4L60/65/70E

PUMP & INPUT SHAFT USAGE

Technical Service Information

Figure 1

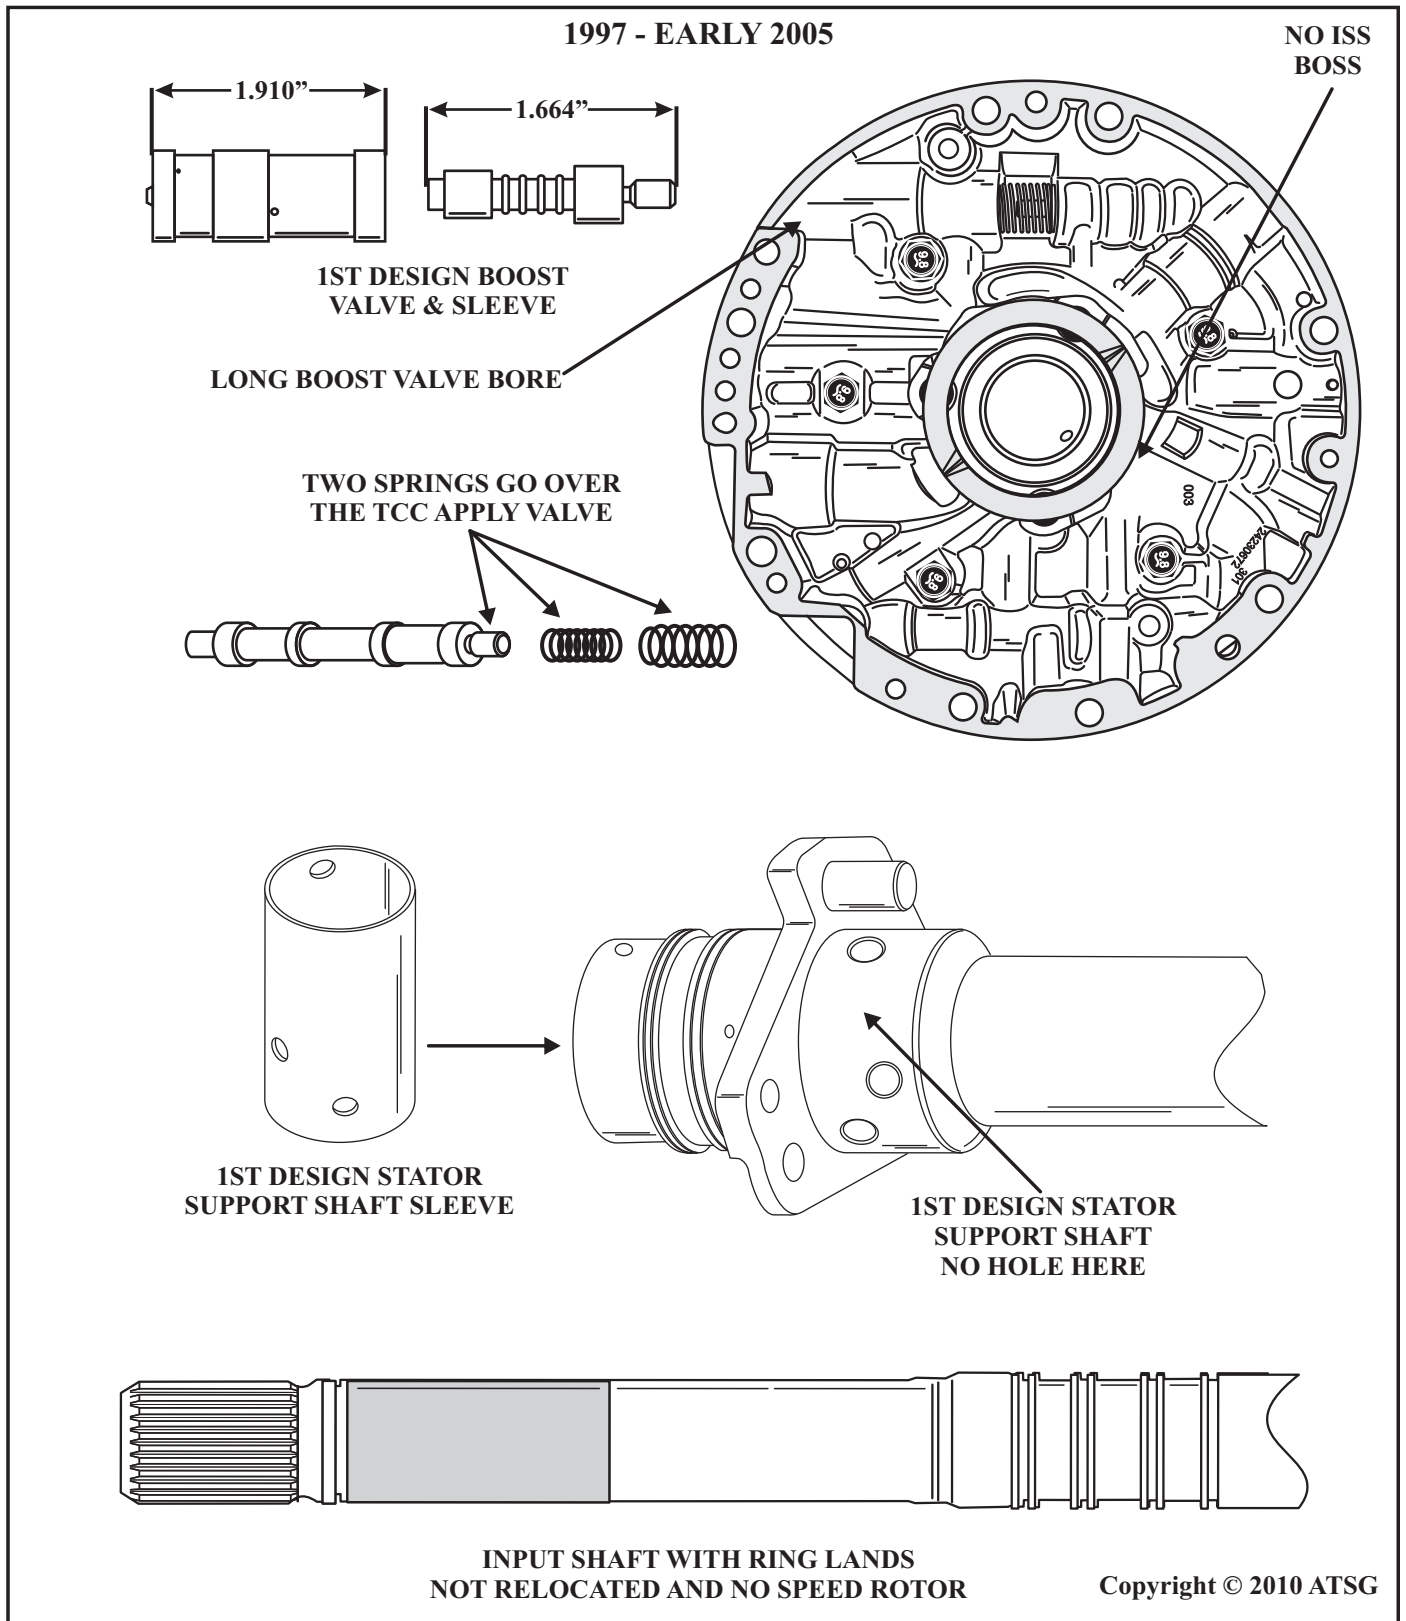
(1) In model years 1997 to early 2005, the 4L60E series transmissions utilized a pump cover with no provisions for an ISS, the input shaft sealing ring grooves had not changed and there was no speed sensor rotor. The pump cover used the 1st design internal stator shaft sleeve and the 1st design boost valve which is 1.664" with a boost valve sleeve of 1.910" in length as well as two springs that went on the TCC apply valve, (Refer to Figure 1).

Figure 2

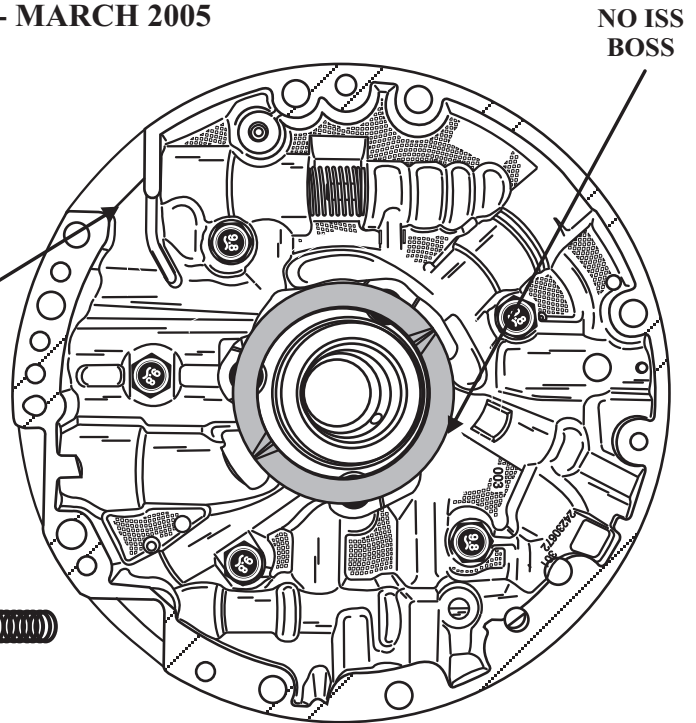
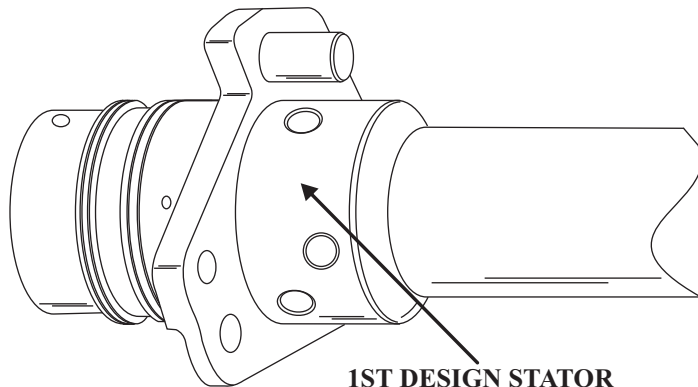
(2) Effective February 1st, 2005, the oil pump cover now uses a new design TCC valve with a single spring, (Refer to Figure 2).

(3) Effective March 7th, 2005, the oil pump cover now uses a more compact boost valve and sleeve. The snap ring groove location for the boost sleeve is now situated 2.57" from the bottom of the bore compared to 2.68" for the previous design. The bore length for the boost sleeve and snap ring has been reduced by approximately 0.110", also seen in Figure 2.

THE BOOST VALVE BORE
HAS BEEN SHORTENED .106"

ONE SPRING GOES INTO
THE TCC APPLY VALVE

Figure 3

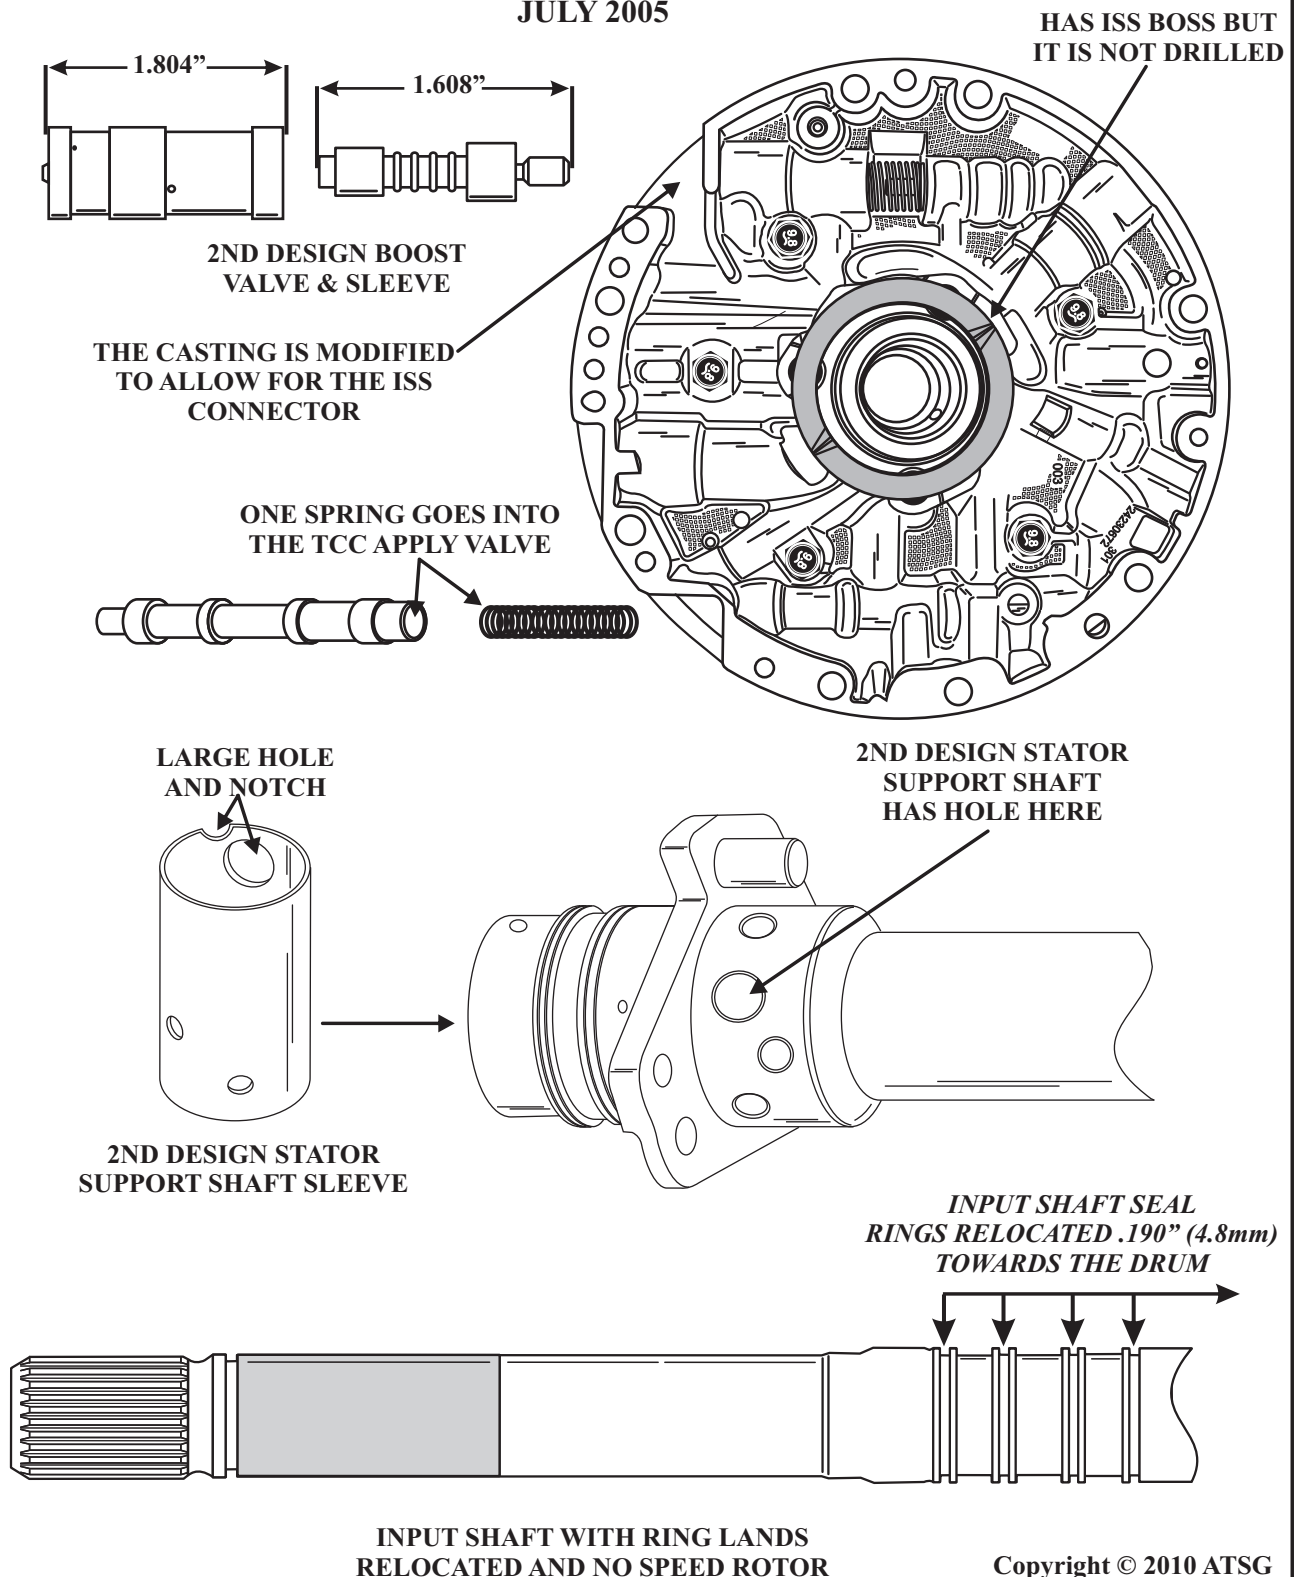
(4) After July 16th, 2005, the pump cover casting was modified in order to situate the ISS connector. This modification removed metal directly below the PR valve and boost sleeve bore and extended a cast wall inward. The internal TCC release passage was also modified at this time. The ISS mounting holes are not yet machined into the oil pump cover, (Refer to Figure 3).

At the same time, the turbine shaft oil seal ring grooves were moved inboard towards the rear of the unit approximately 0.190"(in.) to produce an area with which to manufacture 15 rotor teeth, this can also be seen in Figure 3.

Figure 4

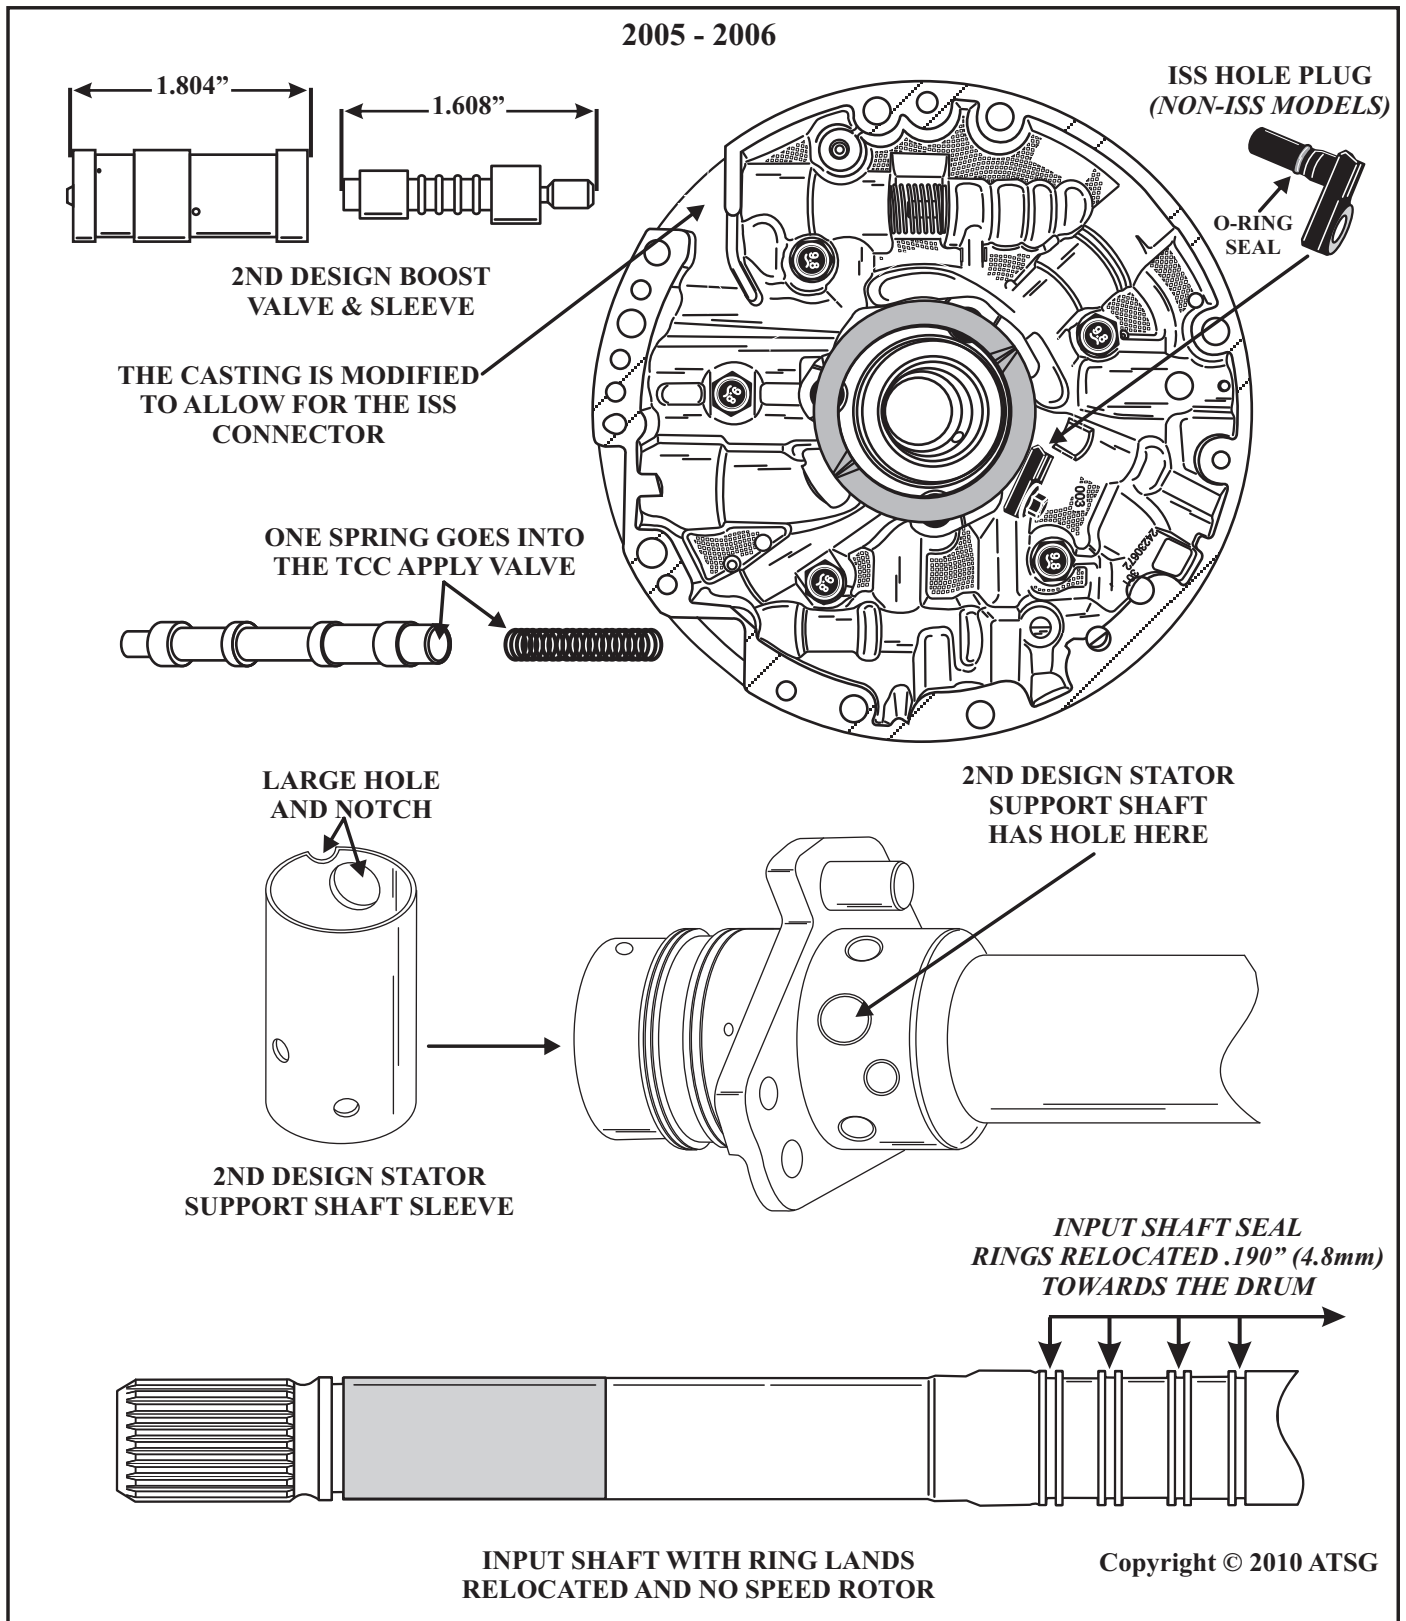
continued: (4) Late in 2005 and early in the 2006 model year, some pre ISS models may still not have the ISS mounting holes machined into the cover. This will be evident as a smooth un-machined surface without the ISS mounting holes. For non ISS models, an ISS hole plug will be used in place of the ISS assembly, (Refer to Figure 4).

On Non-ISS models that have a functional ISS hole in the pump cover, the rubber plug with an o-ring seal must be installed. Failure to do so will result in no converter charge and the vehicle will not move.

Figure 5

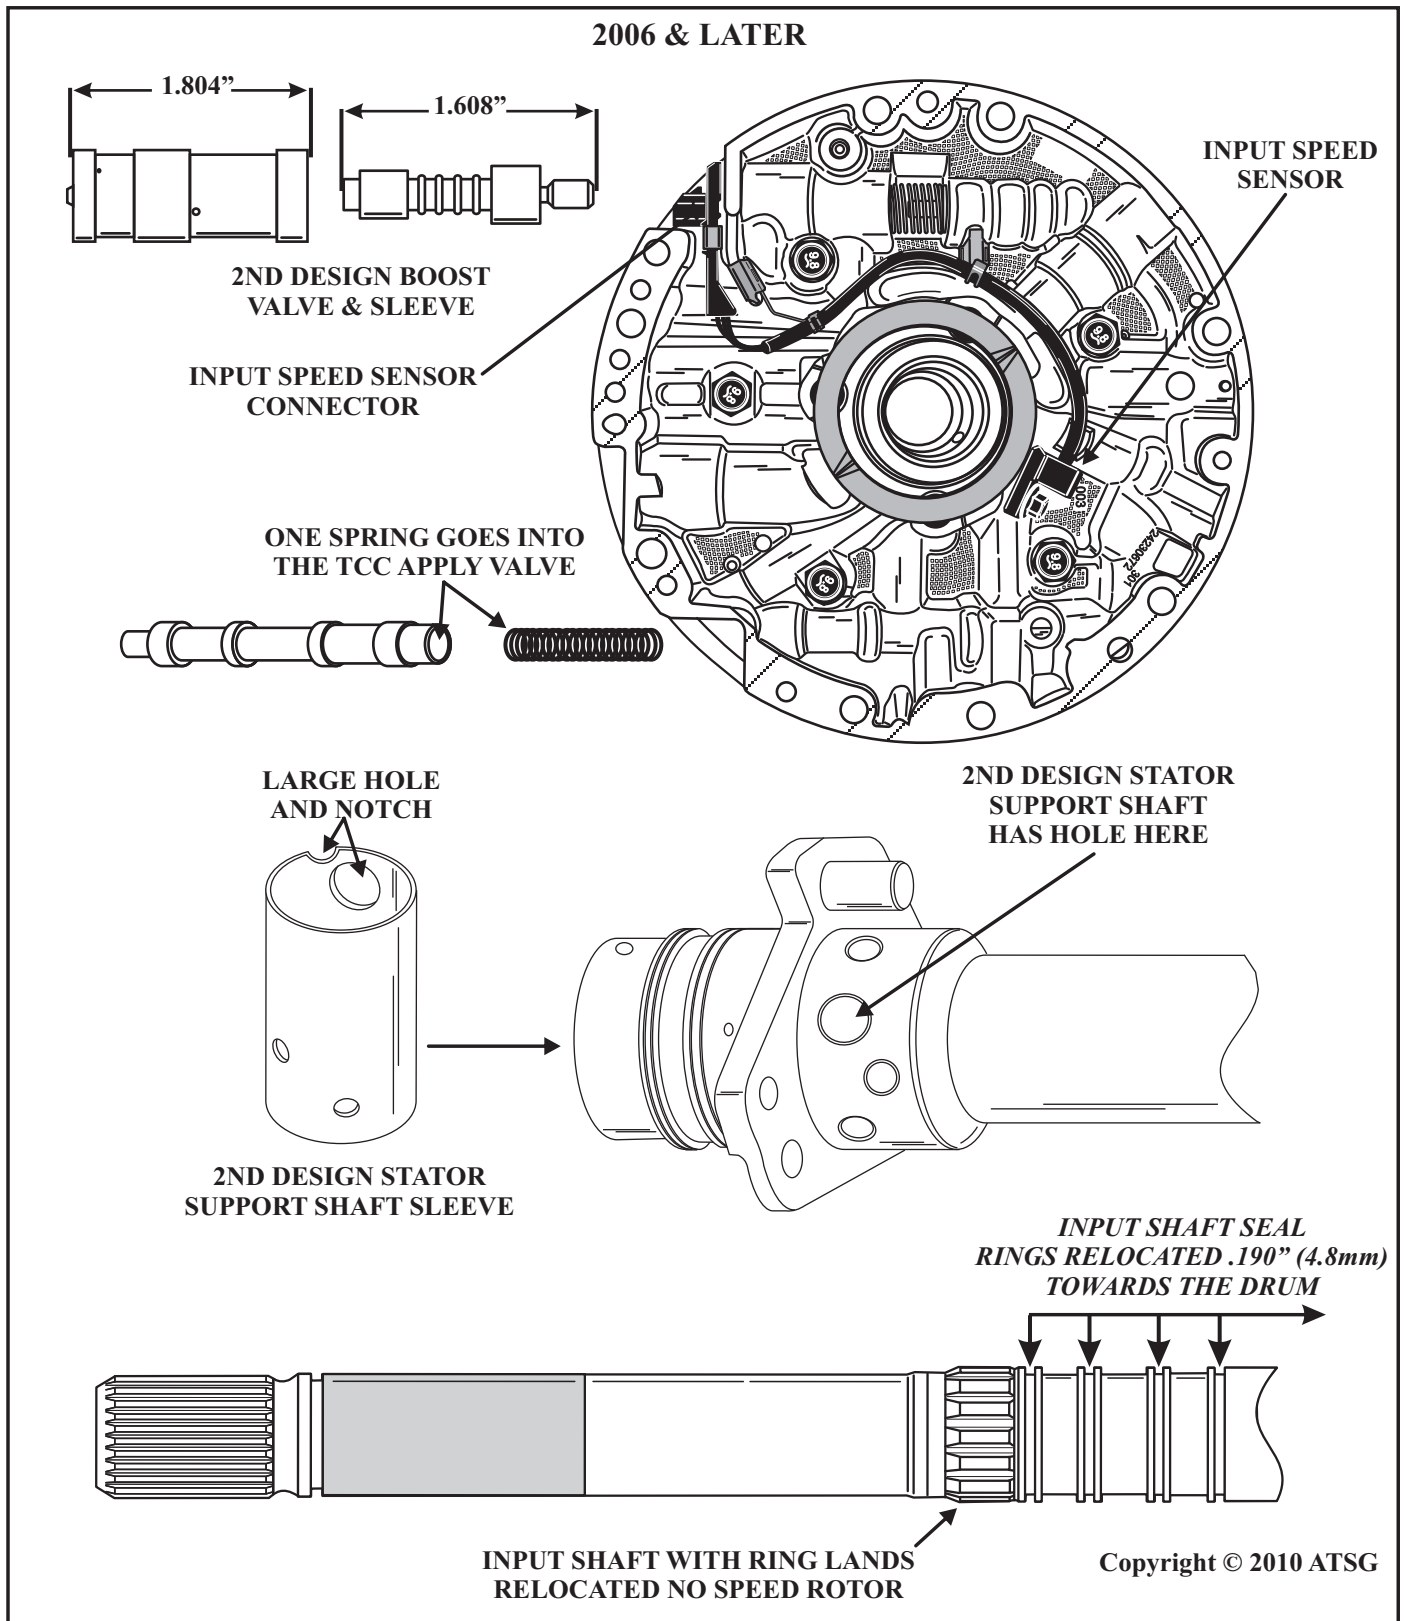
As ISS models were introduced, later in the 2006 model year, the machining took place and the input speed sensor (ISS) was added, (Refer to Figure 5), the presence of the ISS also necessitated a new internal wire harness to accommodate the ISS and software changes to the PCM provided code capability for ISS malfunctions.
